**Offeror Questions and Suggested Government Responses Related to the Request for Proposal (RFP) for Privatization of Ft. Polk, Louisiana Utility Systems.**

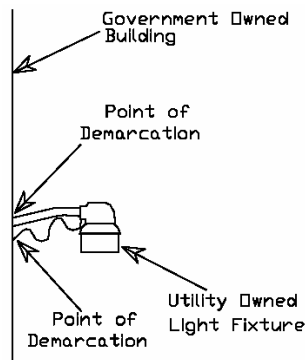
2. Where is the point of demarcation for electrical service to streetlights and area lights? Will the electrical contractor be expected to maintain lights that are fed from buildings or attached to buildings?

**Generally, street and area light PODs are covered by the general PODs listed in Table 2, paragraph J1.2.1.2 for non-residential service. Contractor will be expected to maintain lights that are fed from buildings and those that are attached to buildings. POD will be the building wall line as reflected in the sketch below.**
